# Access Compliance Report

## Public Rights-of-Way

| Intersection ID: 43075                  | Main Street: SCOTT_AV | Cross Street: ROMANY_RD                 | Location: S            |
| ADA ID: E9144644DAFF                    | Ramp Type: Perp       | Initial Pass/Fail: Fail                 | Overall Compliance: No |

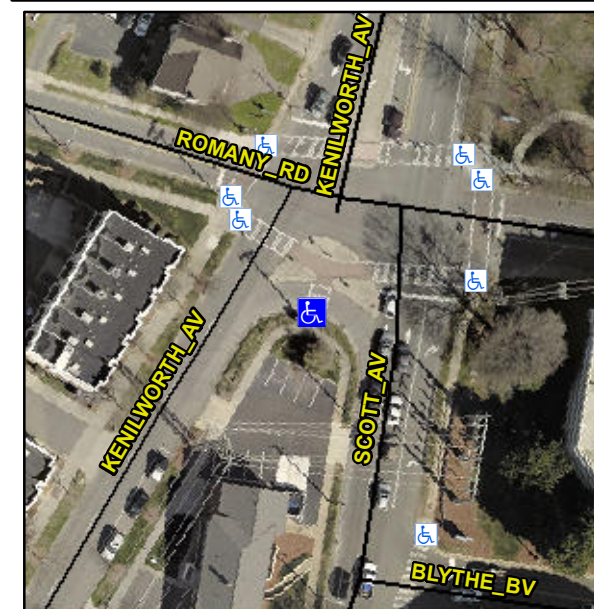
**Not Found, R304.2.2, R304.5.3, R302.7**

| Compliance | Description           | Data  | Compliance | Description                 | Data |
|------------|-----------------------|-------|------------|-----------------------------|------|
| N/A        | Ramp Length (in)      | 45.0  | No         | Ramp Slope (%)              | 19.7 |
| Yes        | Ramp Width (in)       | 48.0  | No         | Ramp XSlope (%)             | 3.7  |
|            |                       | No    |            | Surface Condition? (G/P)    | Poor |

**Remove & Replace Entire Ramp.**
